# Recall Bulletin

**SUBJECT: Loss of Power Steering Assist – Replace Electric Power Steering Motor**

**MODELS: 2005-2010 Chevrolet Cobalt  
2005 Pontiac Pursuit  
2005-2006 Pontiac G4  
2006 Pontiac G5 Pursuit  
2007-2010 Pontiac G5  
Equipped with Electric Power Steering**

The Parts Information and Service Procedure sections in this bulletin have been revised. Technicians are to review the revised information immediately.

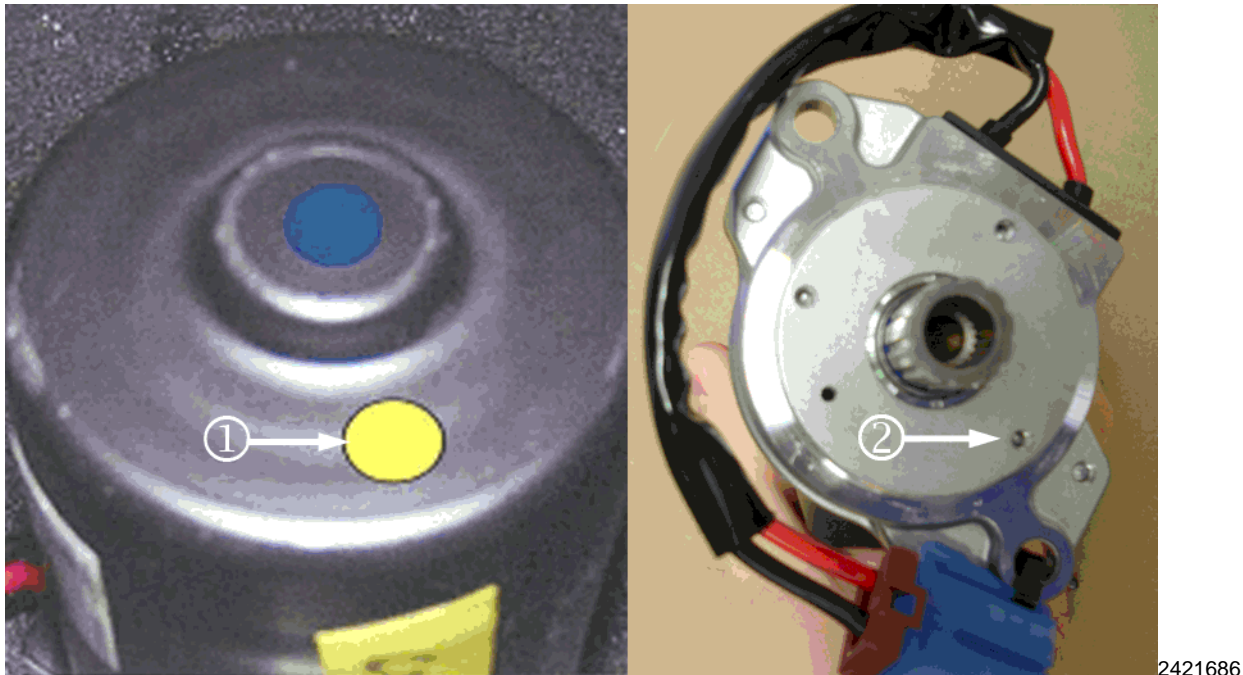
2. Determine what color paint dot is on the bottom side of the EPS motor:
  - If only a blue dot is present then proceed to Step 3 in this inspection procedure.
  - If blue and yellow dot are present then proceed to the *EPS Motor Replacement Procedure* in this bulletin.
  - If only a yellow dot is present then proceed to the *EPS Motor Replacement Procedure* in this bulletin.
  - If only a pink dot is present then proceed to the *EPS Motor Replacement Procedure* in this bulletin.
  - If only a green dot (remanufactured) is present, then proceed to the *EPS Motor Replacement Procedure* in this bulletin.
3. Locate the EPS motor screw hole (2). Refer to the illustration.

**Caution: To avoid part damage, ensure that Loctite 290 is applied to the EPS motor BEFORE it is installed. Only apply the Loctite in the hole as indicated in the illustration. DO NOT apply Loctite to any other hole.**

4. Apply Loctite 290 (P/N 29031) to the EPS motor screw hole (2). Wipe away any excess Loctite. Allow the Loctite to cure for 1 minute.
5. Using a yellow marker, place a yellow dot (1) on the bottom side of the EPS motor as shown in the illustration.
6. Proceed to the *EPS Motor Replacement Procedure* below.
